PUBLIC COMMENTS FOR IBR PROGRAM EXECUTIVE STEERING GROUP

Received between September 13 – October 19, 2021

SUBJECT: Rebuttal of Sept. 15 presentation to ESG regarding Common Sense Alternative II (CSA-II)

WSP USA's "Tunnel Concept Assessment" link

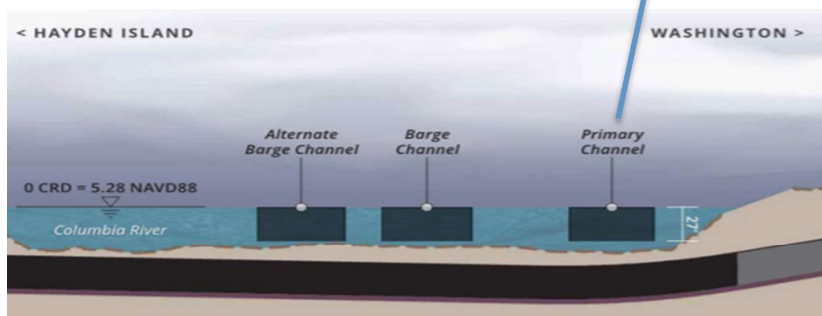
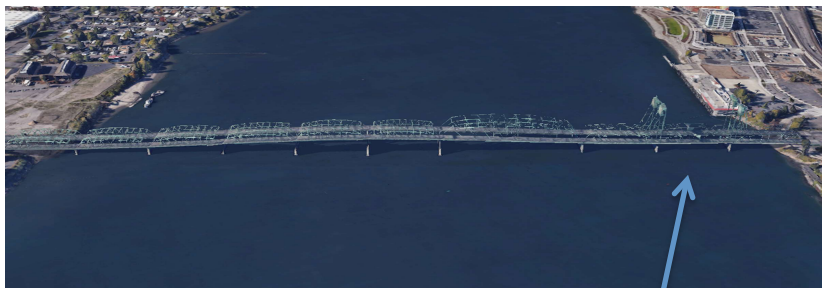
As professional engineers, the Interstate Bridge Replacement Program (IBRP) administrators and WSP USA consultants are obligated to acknowledge an obvious error in their assessment of a Columbia River I-5 immersed tube tunnel (ITT).

The WSP's "Tunnel Concept Assessment" evaluated an ITT under the current primary barge channel at the bridge lift near the Vancouver riverbank. This resulted in an ITT design that is too steep, long, and costly. An ITT under a channel near the center of the river should have been evaluated.

The IBRP administration should contract for two parallel competing design teams, a bridge vs. ITT team. Only then will an ITT get a fair evaluation.

Figure 4. Stacked alignment option

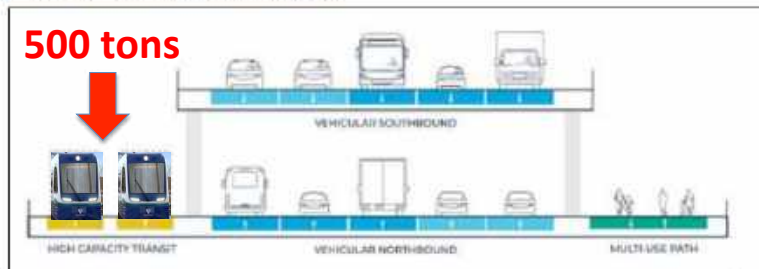
The IBR's "Stacked alignment option" has at least two major problems.

1. Asymmetrical loading

asymmetrical loading

asymmetric load

500-foot truss span

2. Weather and Noise exposure
